**GARFIELD COUNTY BUILDING PERMIT APPLICATION**  
 108 8<sup>th</sup> Street, Suite 401, Glenwood Springs, Co 81601  
 Phone: 970-945-8212 / Fax: 970-384-3470 / Inspection Line: 970-384-5003  
 www.garfield-county.com

9	Describe Work: <b>Roof Repair, i.e., It was a leaky <del>flat</del> roof &amp; changing to 3.5/12 Pitch.</b>		
10	Class of Work: <input type="checkbox"/> New <input checked="" type="checkbox"/> Alteration <input type="checkbox"/> Addition <b>Re-roof</b>		
11	Garage: <input type="checkbox"/> Attached <input checked="" type="checkbox"/> Detached	Septic: <input type="checkbox"/> ISDS <input type="checkbox"/> Community	
12	Driveway Permit:	Owners valuation of Work: \$	<b>10,600.00</b>

**Building Permit No.** 11155

Subject: Panter Garage/Apartment Building Remodel  
45705 U.S. Hwy. 6  
Garfield County, Colorado 81601  
Permit # 11155

Job J0809050	Truss T03	Truss Type COMMON	Qty 7	Ply 1	Jack 1	R29638923
-----------------	--------------	----------------------	----------	----------	-----------	-----------

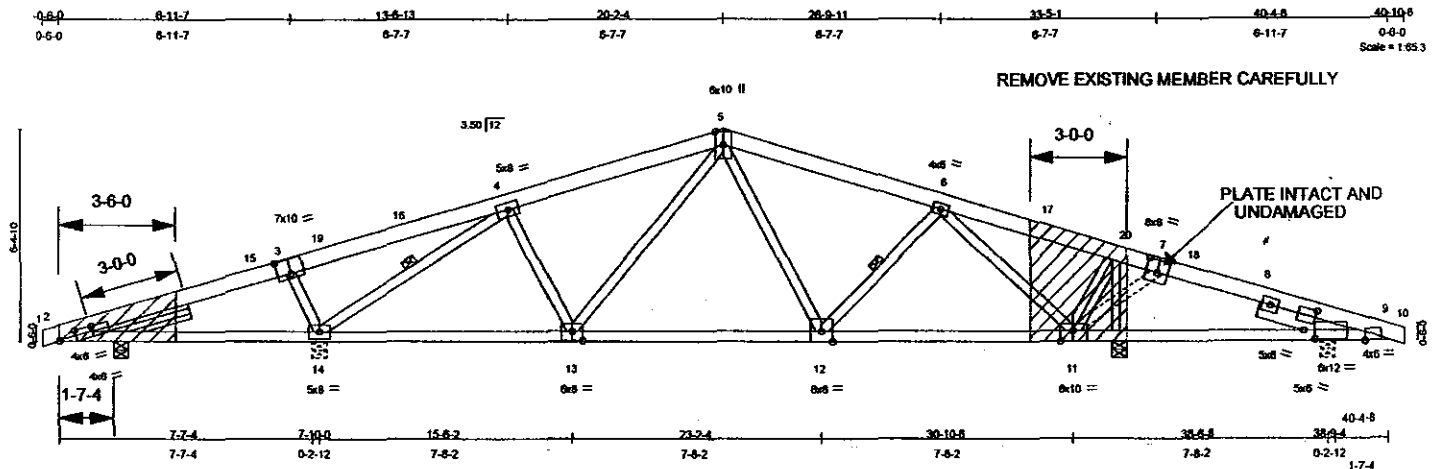
THIS REPAIR IS FOR TRUSS INSTALLED BACKWARDS AS SHOWN ABOVE.

- 1) INSERT NEW 2X8 HF No.2 OR BTR MEMBERS AS SHOWN CUT TO FIT.
  - 2) ATTACH 1/2" CDX, STR. 1, PLYWOOD GUSSETS TO EACH FACE OF TRUSS WITH 10d COMMON NAILS ( 0.148" X 3.0" ) @ 6" O.C., 2 ROWS FOR 2X4 MEMBERS AND 3 ROWS FOR 2X6 MEMBERS WITH MINIMUM AMOUNT OF NAILS SHOWN CIRCLED PER FACE OF EACH MEMBER.
- NOTE: 15/32, EXP. 1, 32/16 SPAN RATED O.S.B MAY BE SUBSTITUTED FOR PLYWOOD.

Job J0809050	Truss T03B	Truss Type COMMON	Qty 4	Ply 1	Jack 1	R29638922
-----------------	---------------	----------------------	----------	----------	-----------	-----------

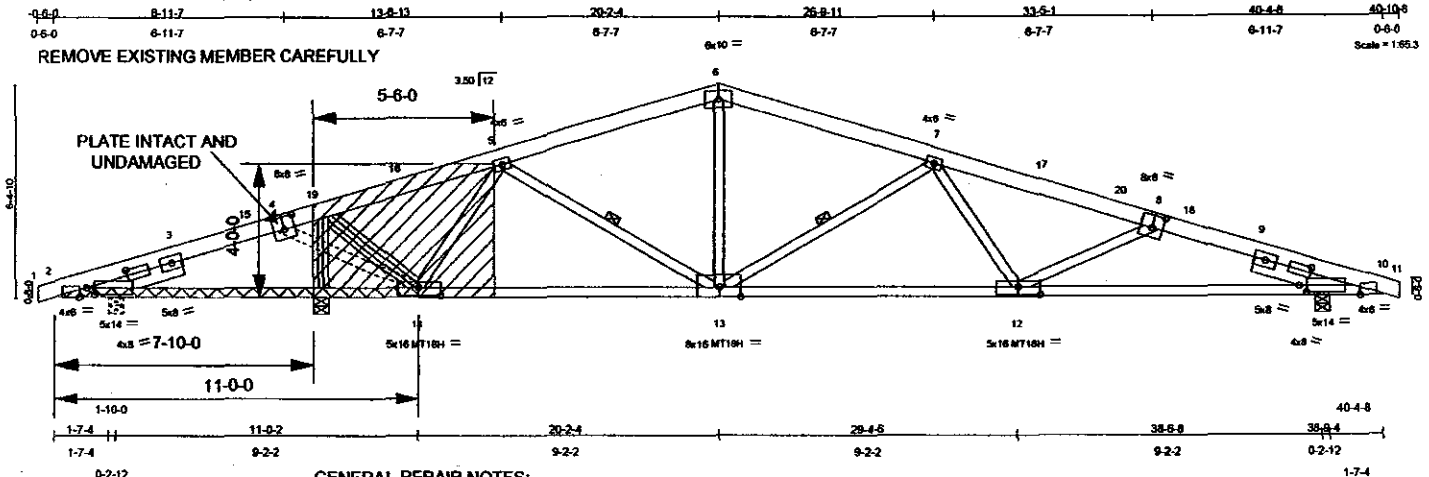
GENERAL REPAIR NOTES:  
THIS REPAIR IS FOR BEARING AT JT.2 MOVED TO 7-10-0 AS SHOWN ABOVE.

- 1) INSERT NEW 2X6 HF No.2 OR BTR MEMBERS AS SHOWN CUT TO FIT.
- 2) ATTACH 1/2" CDX, STR. 1, PLYWOOD GUSSETS TO EACH FACE OF TRUSS WITH 10 D. COMMON NAILS ( 0.148" X 3.0" ) @ 6" O.C., 2 ROWS FOR 2X4 MEMBERS AND 3 ROWS FOR 2X6 MEMBERS WITH MINIMUM AMOUNT OF NAILS SHOWN CIRCLED PER FACE OF EACH MEMBER. NOTE: 15/32, EXP. 1, 3/2/16 SPAN RATED O.S.B MAY BE SUBSTITUTED FOR PLYWOOD.
- 3) ATTACH 2X4 SPF 1650F 1.5E SCABS AS SHOWN TO EACH SIDE OF TRUSS WITH 16d COMMON NAILS ( 0.162" X 3.5" ) 2 ROWS @ 6" O.C. ADD 1/2" PLYWOOD SHIMS WHERE SCABS NOT OVER PLAYWOOD, USE SCAB NAILS FOR GUSSET NAILS, DO NOT DOUBLE NAIL.

# TRUSS PLACEMENT PLAN

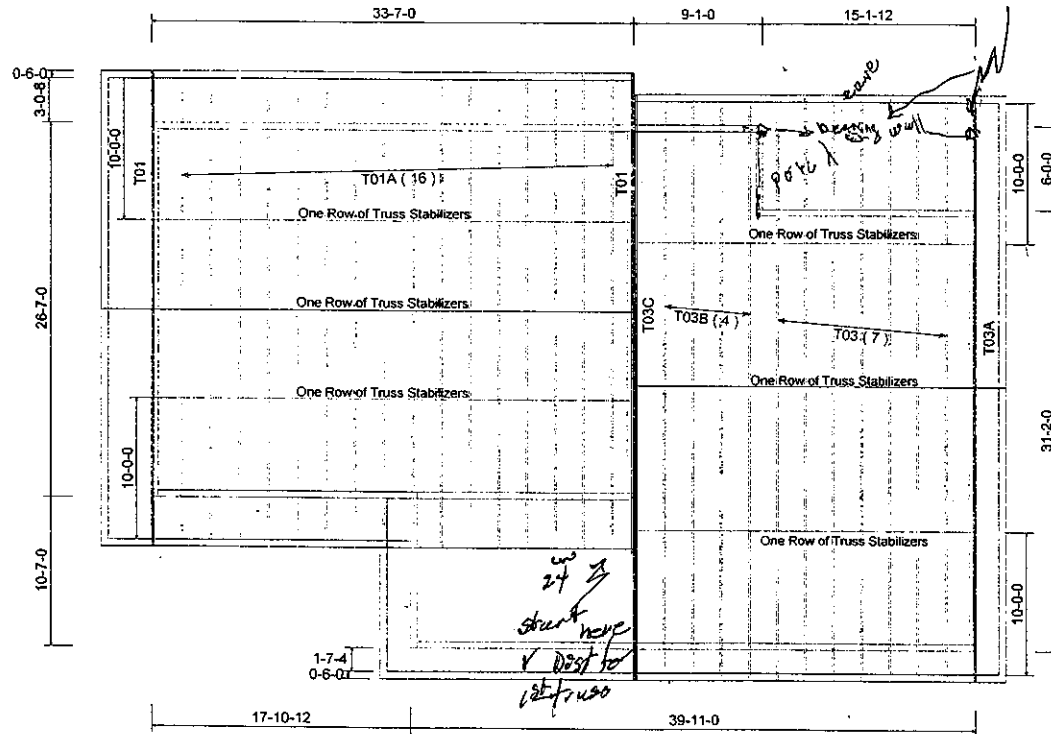
- 1) add Bracing Per truss drawings
- 2) extend Venting to outside
- 3) Verify Bearing of Truss with Manufacture & have a stamped Letter showing location of Bearing
- 4) access to other area spotted
- 5) ok to shingle with letter from truss company
